October 16, 2024

RE: Comments on Rural Lands West Mixed-Use Community (Clean Water Act Section 404 Permit Application No. SAJ-2008-02431 (SP-MAO); Request for Public Hearing

¹⁷⁸ See Declaration of Robert Frakes at ¶ 46, Figures 5 and 6.

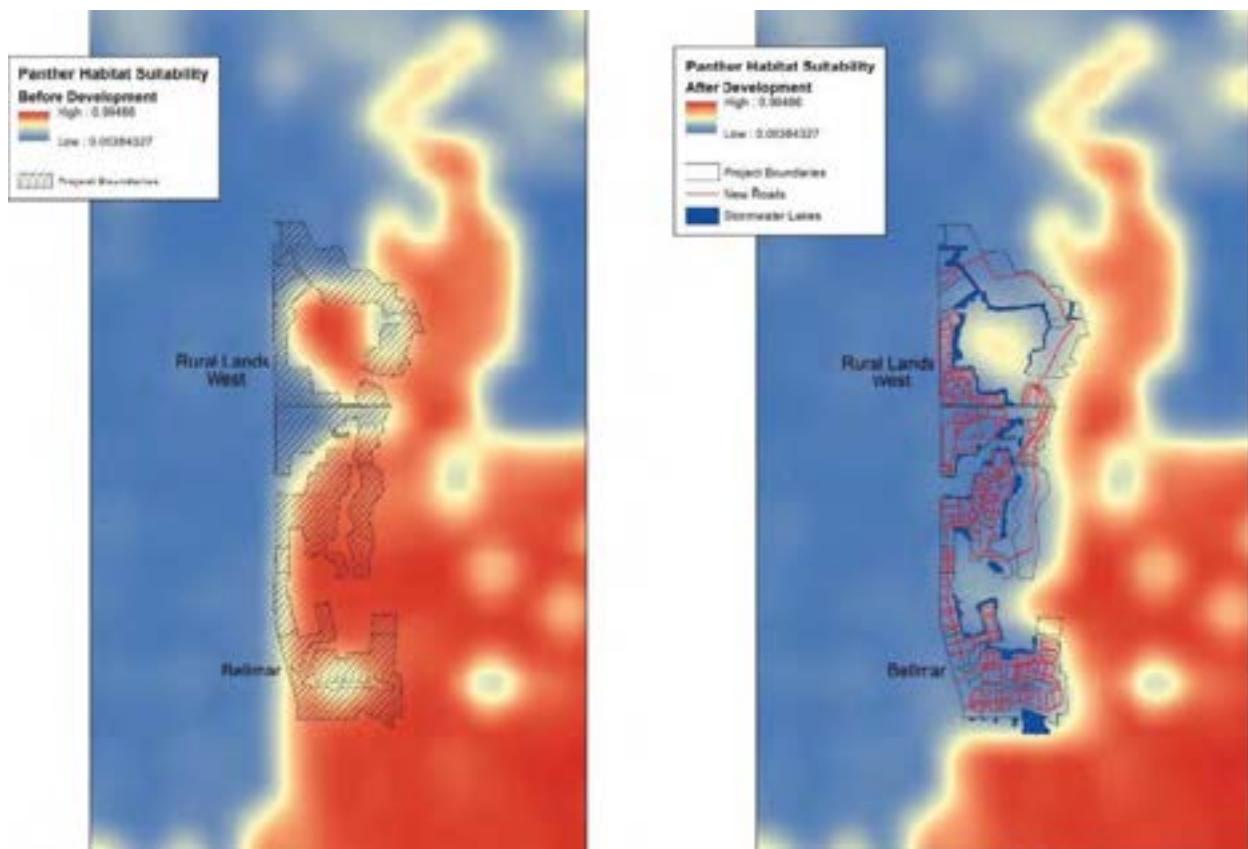
*Figures Prepared by Dr. Frakes:*¹⁷⁸

48. Figure 7 shows the existing north-south panther habitat connection (Camp Keais Strand) between Florida Panther National Wildlife Refuge and Corkscrew Swamp, in relation to the proposed location of the Bellmar and Rural Lands West developments. Figure 8 shows the predicted impacts to this important corridor after development of the two projects. The predicted narrowing of this corridor as shown is likely to adversely impact north-south panther movements in this part of their range. Connectivity to the north is essential for panther recovery.

¹⁷⁹ See Declaration of Robert Frakes at ¶¶ 47–48, Figures 7 and 8.

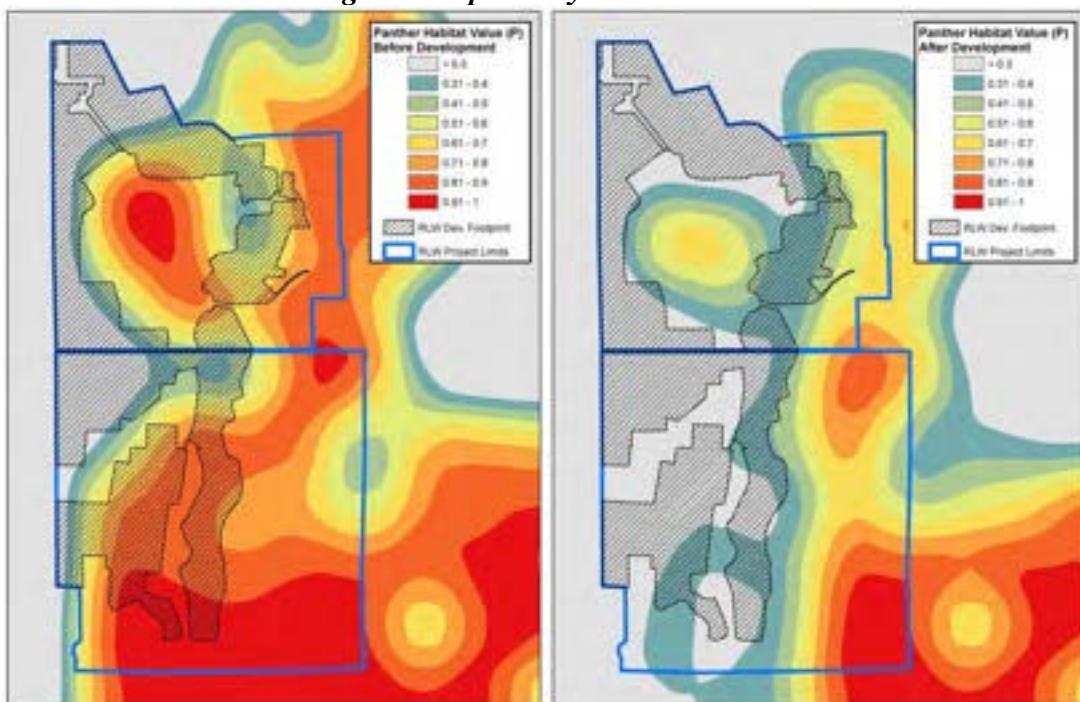
Figures Prepared by Dr. Frakes¹⁷⁹

Summary of Prior Analysis by Dr. Frakes of Rural Lands West:

Figure 9

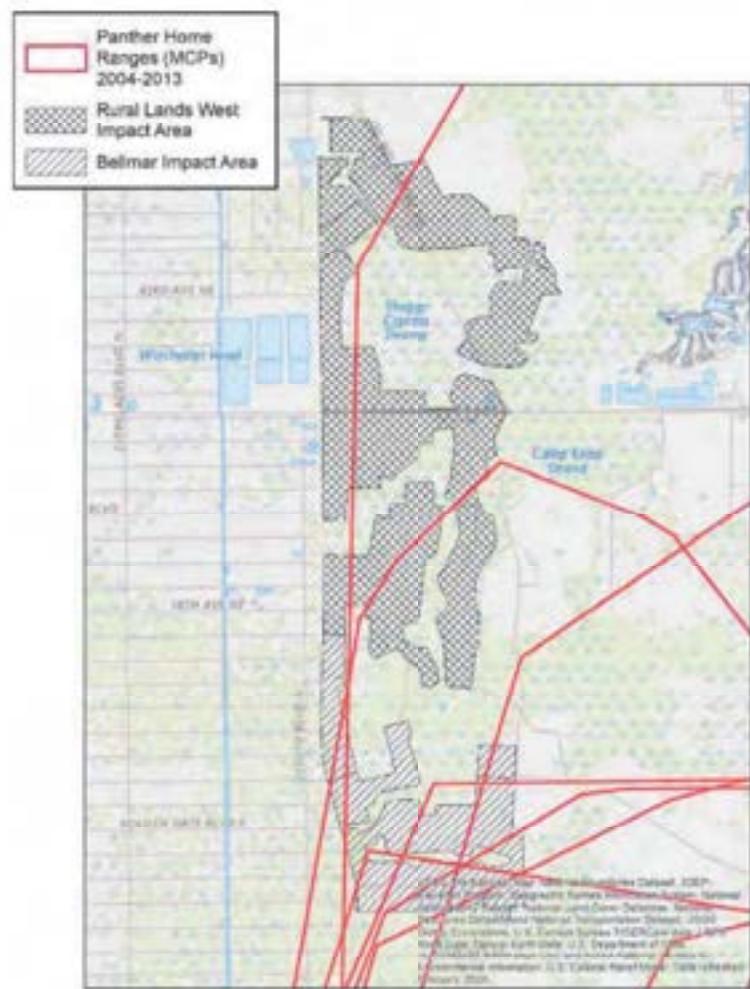
57. For example, when analyzing Bellmar, FWS made a mistake by comparing the project area to the average size of a single panther home range and to conclude that the project only affects a small percentage of a single panther home range. This approach is incorrect and misleading. As revealed by analysis and mapping in paragraph 49 and Figure 9, the Bellmar project alone is likely to impact multiple panther home ranges.

Figure 1. Locations of known caracara nests associated with the Rural Lands West project and known nests in adjacent areas.

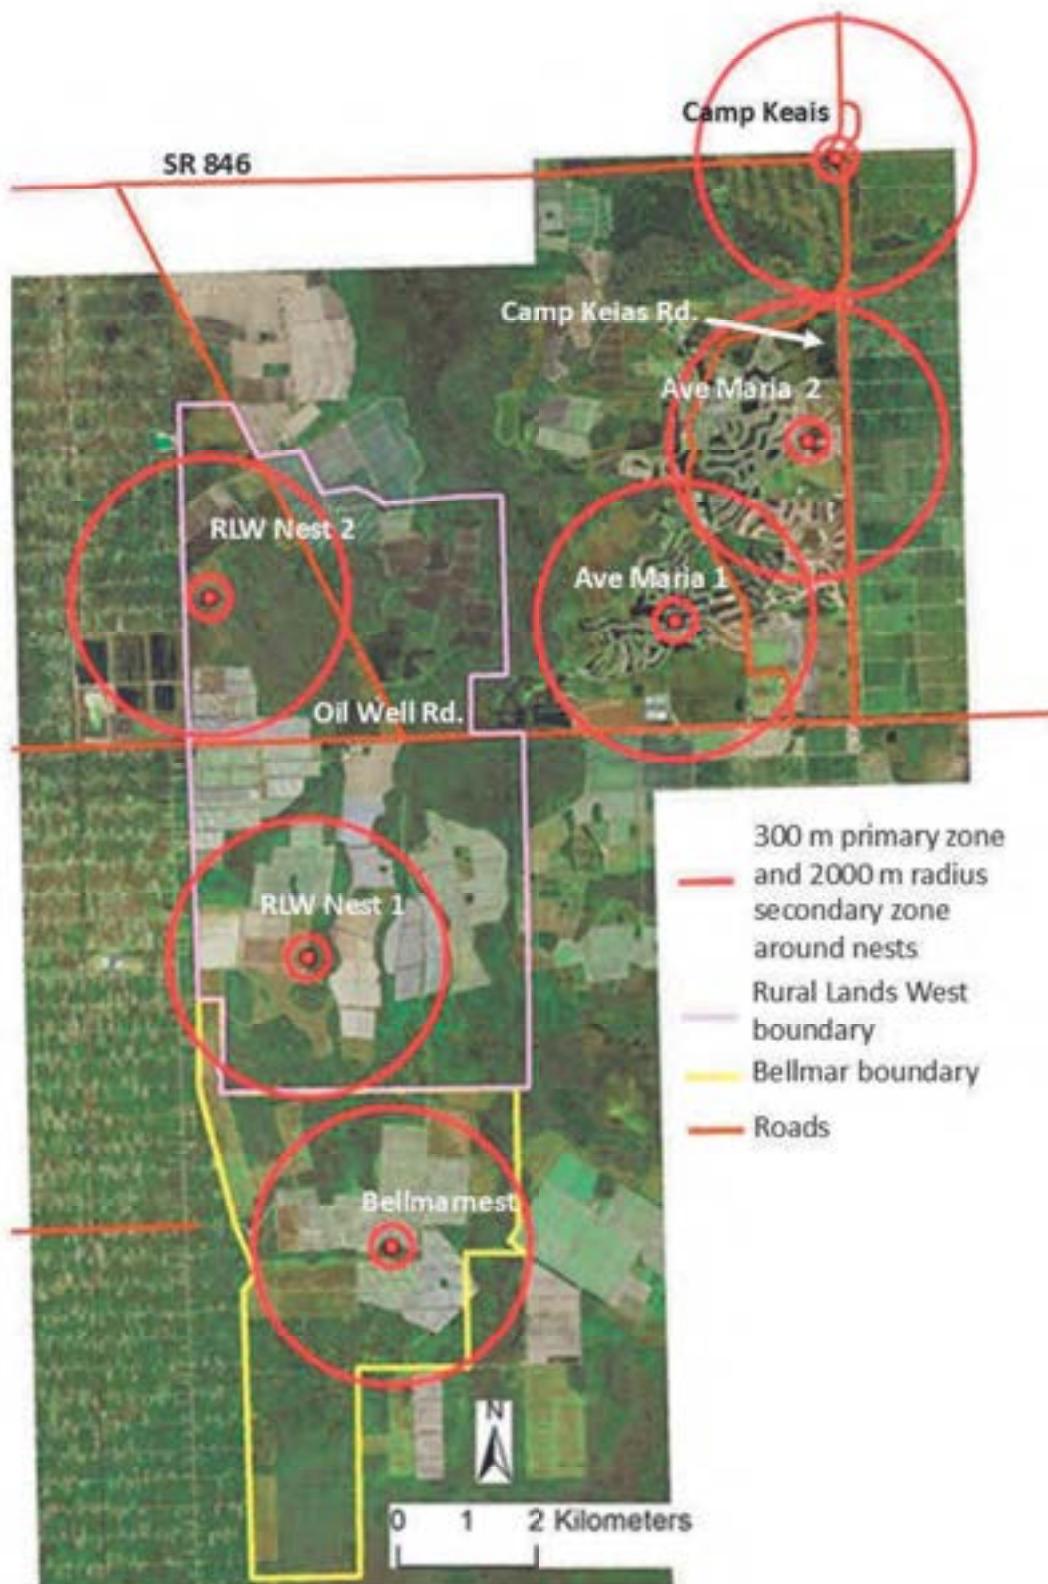
39. Based on previously identified nests in areas near the Rural Lands West site, there likely are other breeding pairs in these nearby areas. See **Figure 1** below. As shown in Figure 1, which I created based on nest locations that either have been documented in publicly available reports or that I have personally observed, there are several known caracara nests in the general vicinity of the proposed Rural Lands West development. The location of the two nests within the footprint of the Rural Lands West site are based on survey information in the 2024 Biological Assessment report for the Rural Lands West project (page 47 and Exhibit 14), which describes both nests as active in 2023. See Appendix D (Literature Cited). The location of the nest within the Bellmar site was reported in a Biological Assessment report for the proposed Bellmar project, which describes a nest located in 2009. See Appendix B at ¶ 32–34. The other three nests shown on Figure 1, at the Ave Maria sites are nests that I have observed personally within the last three years and all have been active and produced young during those years.

40. The distances between the three nests in Figure 1, two observed on the Rural Lands West site in 2023 and one observed in 2009 on the proposed Bellmar site indicate that these nests are associated with three different breeding pairs. The two nests on the proposed Rural Lands West development are ~5.4 km apart, and the distance between RLW Nest#1 (the southern nest) and the nest on the proposed Bellmar project area is ~4.3 km. The average distance between neighboring nests (3.4 km, $n = 29$ nest pairs, Morrison and Dwyer 2023), indicates that the two Rural Lands West nests and the Bellmar nest represent three pairs. Similarly, the three nests associated with the Ave Maria development are from 6 to 14 km from the two nests on the proposed Rural Lands West development and the Bellmar nest, and therefore represent yet another three breeding pairs. Although the three nest sites are associated with the Ave Maria

48. The area within 300 m of a nest tree is approximately 70 acres, ~2% of a caracara’s home range, insufficient area to support a breeding pair. See Figure 1, below, which I prepared using information about the location of the nests described in the Biological Assessment reports for the Rural Lands West project from surveys conducted in 2023, from the Biological Assessment report for the Bellmar project from surveys conducted in 2020, and from my own knowledge of nest sites. See Appendix B and Appendix D. Mitigating for destruction occurring only in this 70 acre area at each nest site is insignificant if other habitat is destroyed.

62. From mapping and given the distance between the Bellmar nest and the nest 'north' of the Bellmar site, I believe that the nest 'north' of the Bellmar site is the same as Nest #1 of the RLW site (see **Figure 1**). To clarify, there are at minimum three pairs that would be affected directly by completion of both the Bellmar and the RLW developments. (As explained above and in Appendix B, there is not adequate evidence to show that the breeding pair previously detected nesting on the Bellmar site is no longer using that breeding territory.) All three pairs would be harmed by the loss of foraging habitat from the construction footprints that will destroy foraging habitat at both developments. Other adjacent pairs would likely be affected as well, as the pairs displaced from the Bellmar and RLW developments try to establish territories in adjacent areas that may already be occupied. This is an example of the larger, cumulative effects of multiple projects being conducted across the caracara's range in Florida. Removal of foraging habitat and nest trees resulting from both developments further limits areas where 'displaced' pairs from all three nest sites can move to.

Figure 2. All acreages that contain at least some foraging habitat that may be used by caracaras at Nest 1 and Nest 2. See legend on next page.

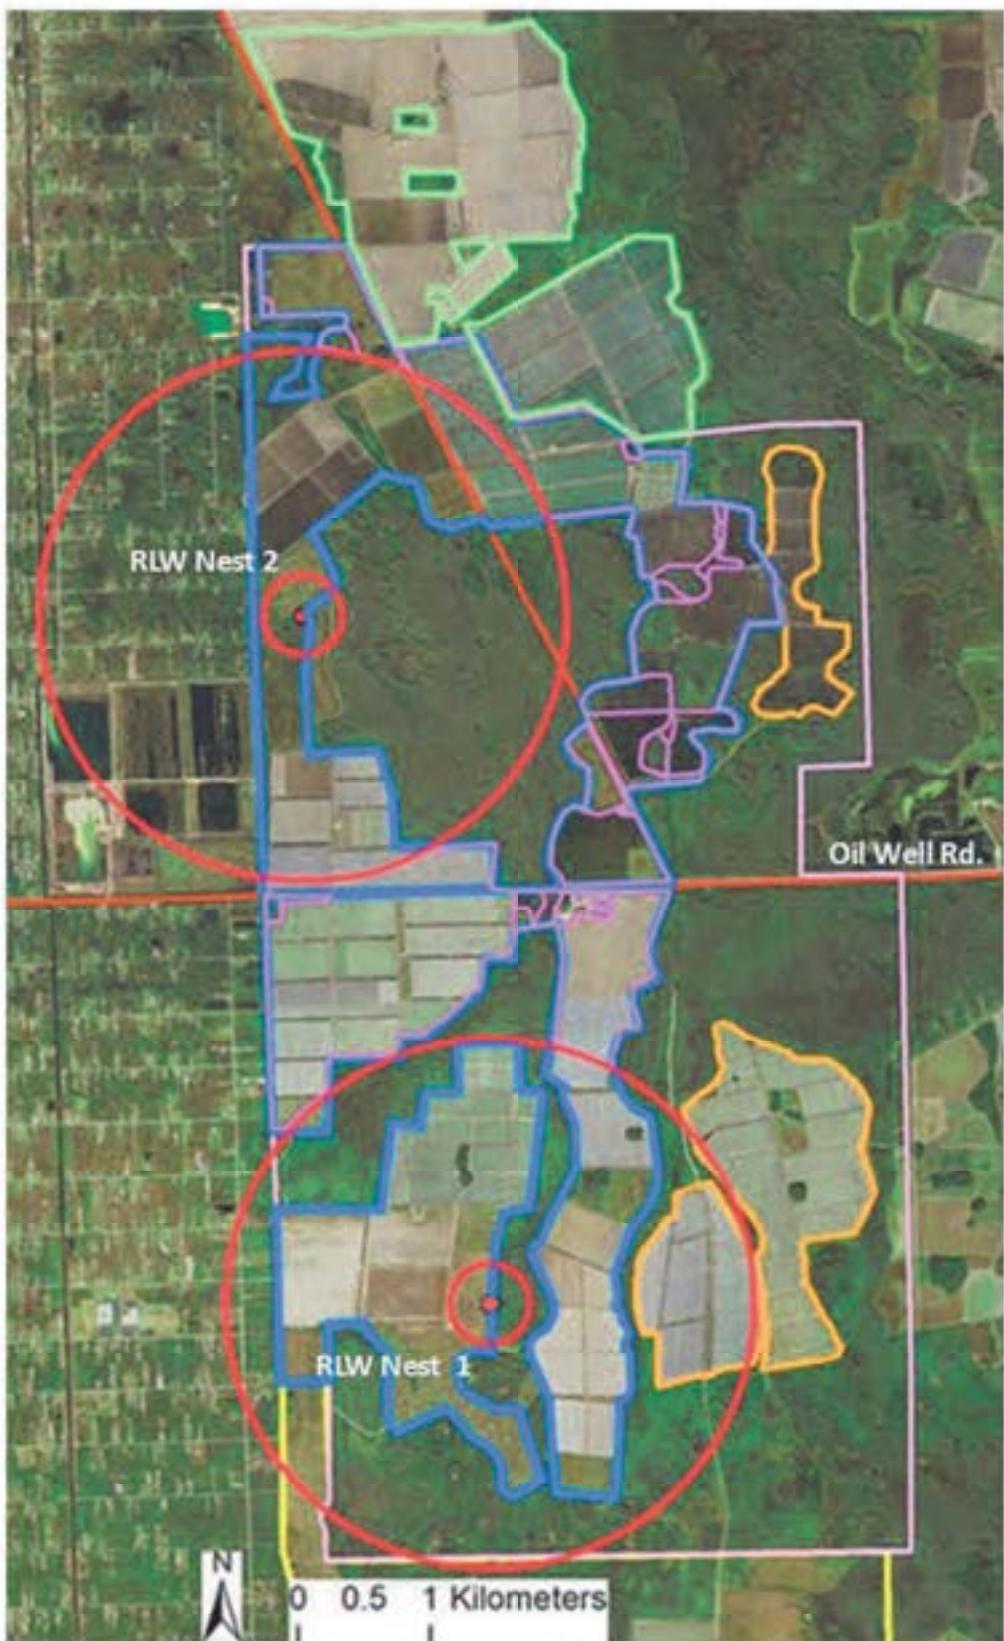
35. Nest 1. The project footprint includes development of ~ 1336 (42%) acres of the 2000 m radius buffer around Nest 1 (the southern nest). Within these 1336 acres are 1316.2 acres of foraging habitat (Figure 2), or 41% of the total buffer area; these 1316.2 acres will be lost to the RLW development. It is not appropriate to assume that a caracara's territory is circular around the nest, thus, the caracaras are likely also foraging in the ~937.8 acres of agricultural lands just north of the Nest 1 buffer. These acres are within 3 km of Nest 1, so their use by this pair is a reasonable assumption. These 937.8 acres are also within the RLW development area so will be lost (Figure 2).

37. Nest 2. The project footprint includes loss of ~923 acres (~29%) overall, within the 2000 m radius buffer around Nest 2 (the northern nest) (**Figure 2**). Within these 923 acres are 901.7 acres of foraging habitat, or 28% of the total buffer area (**Figure 2**); these 901.7 acres will be lost to the RLW development. There are no acres of foraging habitat within the 2000 m buffer around Nest 2 that are not in the RLW development area. There are ~1704 acres of agricultural land outside the Nest 2 buffer but within the RLW development area and 184.7 acres of agricultural land outside the RLW development area but within the overall RLW project boundary (**Figure 2**). These ~1889 acres are likely being used as foraging habitat by the Nest 2 pair. Again, a breeding caracara pair's territory is likely not circular, and these other areas of foraging habitat are within 3 km of Nest 2, so their use by this pair is a reasonable assumption. The 1704 acres will be lost to the RLW development, whereas the 184.7 acres inside the RLW project boundary appear to be lands owned by Gargiulo, Inc. subject to a 30-year deed restriction imposed in 2019, and so ultimately may be developed after that time unless additional restrictions are somehow imposed. Finally, there are an additional 1600 acres of agricultural land outside the RLW project boundary (**Figure 2**) that are likely being used as foraging habitat by the Nest 2 pair. These acres also appear to be owned by Gargiulo and subject to a 30-year deed restriction imposed in 2019, and so ultimately may be subject to development unless additional restrictions are somehow imposed. Given the landscape north of the Nest 2 buffer, there likely is another pair of caracaras in this area, so if the Nest 2 pair are displaced to forage outside the RLW project boundary, they may incur competition from another resident pair.

(2254 and 2606 acres respectively) that are likely being used by these pairs (**Figure 2**), along with at least 2 nest trees and other habitats used for perching and resting. Such loss likely will cause loss of reproductive success for the affected pairs for more than just the first year of the Project because the habitat loss is permanent and because the displaced pairs will likely have to compete with adjacent pair(s) for nest sites and foraging habitat. Based on telemetry data from breeding caracaras associated with habitat conversion projects in other areas I have been involved with, loss of the nest tree and this proportion of acreage of foraging and other used habitats will likely cause the breeding pair to abandon the original site and shift to a nearby area, if one is available.
